APPLICATION NO.	FILING DATE	FIRST NAMED INVENTOR	ATTORNEY DOCKET NO.	CONFIRMATION NO.
10/764,302	01/26/2004	Glen R. Chartier	RTEE 2 13410-1	8267
7590	07/09/2004		EXAMINER	
E. Kent Daniels, Jr. Fay, Sharpe, Fagan, Minnich & McKee, LLP Seventh Floor 1100 Superior Avenue Cleveland, OH 44114			MEISLIN, DEBRA S	
			ART UNIT	PAPER NUMBER
			3723	
			DATE MAILED: 07/09/2004

Office Action Summary	Application No.	Applicant(s)
	10/764,302	CHARTIER ET AL.
	Examiner Debra S Meislin	Art Unit 3723

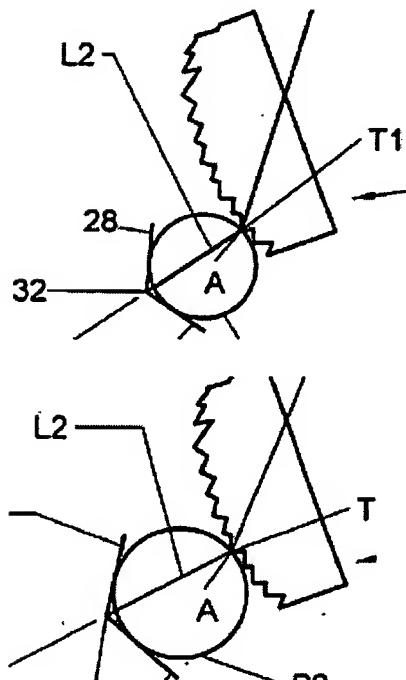
Gunnarson discloses the claimed subject matter as was set forth in the parent application with reference to attachment "A".

Attachment "A" is an enlargement of figure 1 of Gunnarson. The plurality of teeth are shown as lying along the fixed jaw "B". The blue markings show at least three of the plurality of discrete teeth wherein each discrete tooth is for engaging one of a plurality of workpieces having different diameters. The remaining discrete teeth lie between teeth "1" and "2" and between teeth "2" and "3". Teeth are located between adjacent ones of the discrete teeth (the teeth between the discrete teeth that do not engage a workpiece) since not all of the teeth engage a workpiece. Note that Gunnarson discloses nine workpieces and twenty teeth on the fixed jaw. Gunnarson discloses the camming angles as marked in red for at least three of the discrete teeth with corresponding workpieces.

Additionally, Gunnarson discloses "said teeth including a plurality of discrete teeth, each discrete tooth being for providing single tooth contact with a different one of a plurality of cylindrical workpieces" and "just the one said plurality of discrete teeth provided on said fixed jaw for the workpiece of a given diameter". The discrete teeth are shown in attachment "A" (previously sent to applicant in the parent application and attached to the preliminary amendment filed January 6, 2004 in the instant application), wherein there is single tooth contact (by either tooth 1, tooth 2, or tooth 3) of the discrete teeth provided for contact with a different one of a plurality of cylindrical workpieces and just one (tooth 1, tooth 2, or tooth 3) of said plurality of discrete teeth provided on said fixed jaw for the

workpiece of a given diameter. The remaining teeth in Gunnarson define the teeth between adjacent ones of the discrete teeth. This is similar to applicant's invention wherein teeth "50" also engage the workpiece.

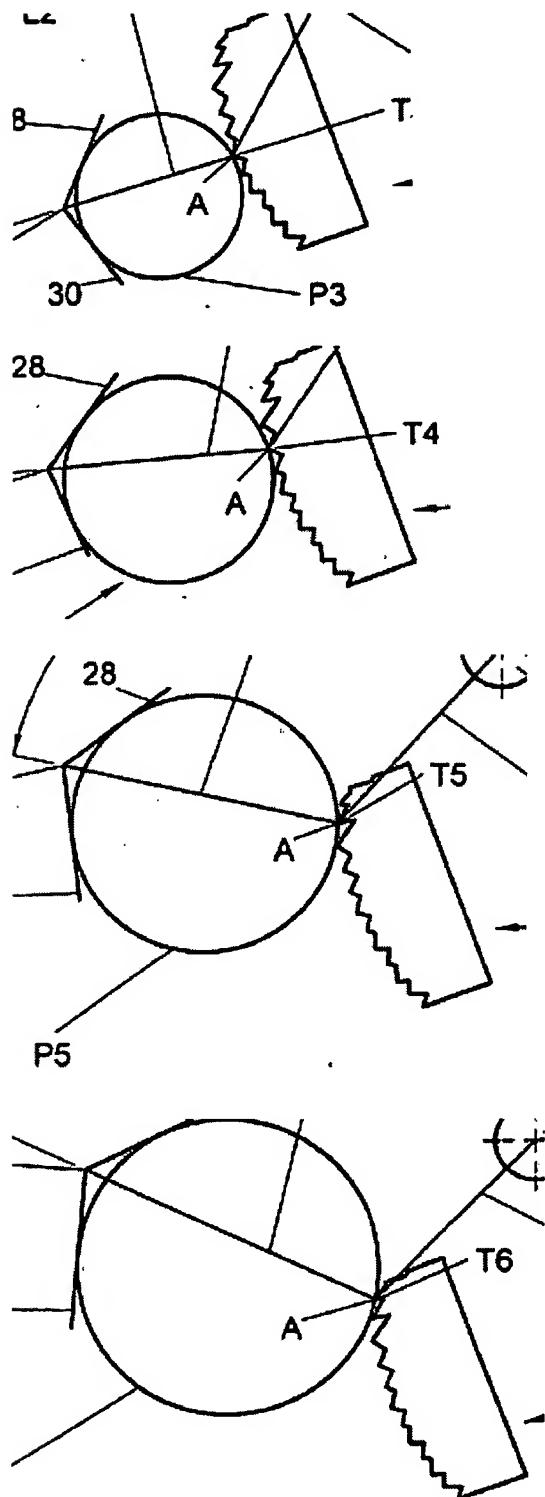
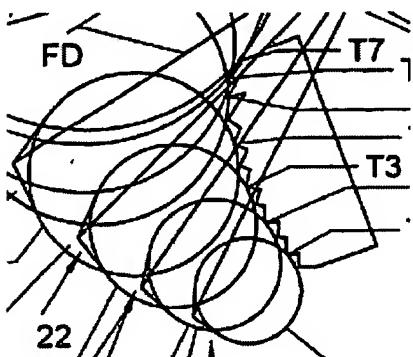
Applicant appears to be arguing that Gunnarson discloses plural teeth engaging the workpiece and not a single tooth. It is noted that applicant's invention also discloses

plural teeth that engage the workpiece, wherein one of the teeth includes a discrete tooth. Note figures 6A-F and figure 7, below, of the instant application wherein a discrete tooth and an additional tooth engages the workpiece just as the teeth of Gunnarson do. Page 5, lines 13-17 of the instant application also defines discrete teeth and additional teeth to promote gripping.

15 T7 also accommodates gripping a 1-1/2 inch pipe fitting. While it is not necessary to provide any additional teeth on jaw member 18 other than the discrete teeth T1-T7, it is preferred to provide additional teeth 50 between adjacent ones of the discrete teeth T1-T5 to promote the gripping capability of the wrench with regard to pipe fittings, rod and other objects and workpieces in addition to the series of pipes. While reference herein is with regard to the foregoing nominal pipe sizes, it
